WILLBROS ENGINEERS, INC.

APPENDIX E
PACDIV COMMENTS AND WILLBROS RESPONSES

PROJECT TITLE	CONTRACT NO. N62742-89-C-0069	DATE 28 Sep 94	PAGE 1 OF 4
FIRE/RISK ASSESSMENT STUDY, RED HILL TUNNEL COMPLEX		DD FORM 1391	DESIGN CRITERIA
		PRELIM. PLANS	FNL SPCS & PLNS

EXHIBIT 4-1 (continued)

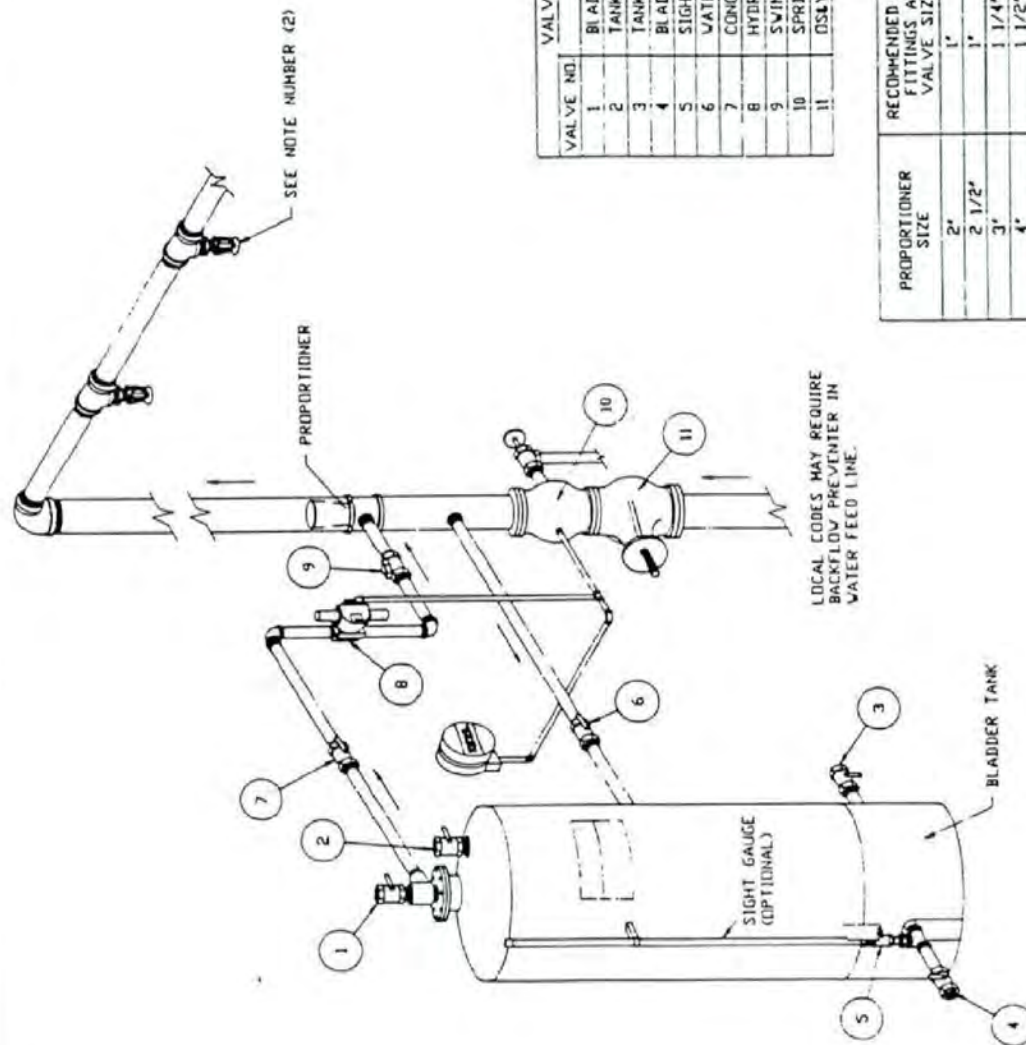
DWG NO. OR SPEC PARA. NO.	ITEM NO.	COMMENTS	ACTION
P. 4-31	9	Section 4.6.2.9, Fire Suppression: a. Provide a concept sketch of the recommended AFFF deluge system.	sec- Exhibit 4-1
		b. Discuss why AFFF deluge system was selected, i.e., why not other alternative systems? Also, see comment item no. 1.c. above.	See Sectn. 4.2.15
P. 4-31	10	Section 4.6.2.10, Ventilation: a. See comment item no. 6 above.	
		b. 2nd sentence: is this bulkhead door have an automatic closure device? Is one recommended/necessary?	Sectn. 4.6.2.10 revise.
P. 4-32	11	Section 4.6.2.11: Please elaborate on this sentence: i.e., what kind of "centralized role" should FISC play in the Fire Protection Program? Their staffing is limited.	Sectn. 4.6.2.11 revised
